To: T10 Technical Committee
 From: Mahbubul Bari (bari@vitesse.com)
 Subject: SAS-2 Return Loss Measurement Methodology

Return loss measurement methodology.

Figure B.14 — S-parameters for single-ended and differential systems

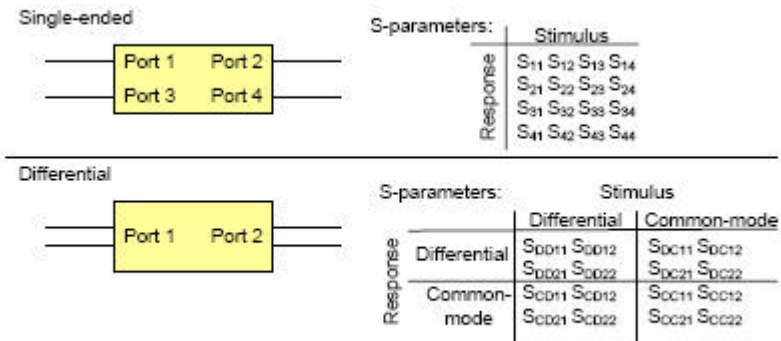
Section B.9 in Annex B describes S-parameter measurements. Add single ended to differential S-parameter derivation section.

Figure B.14 shows the set of S-parameters for a single-ended system and for a differential system.
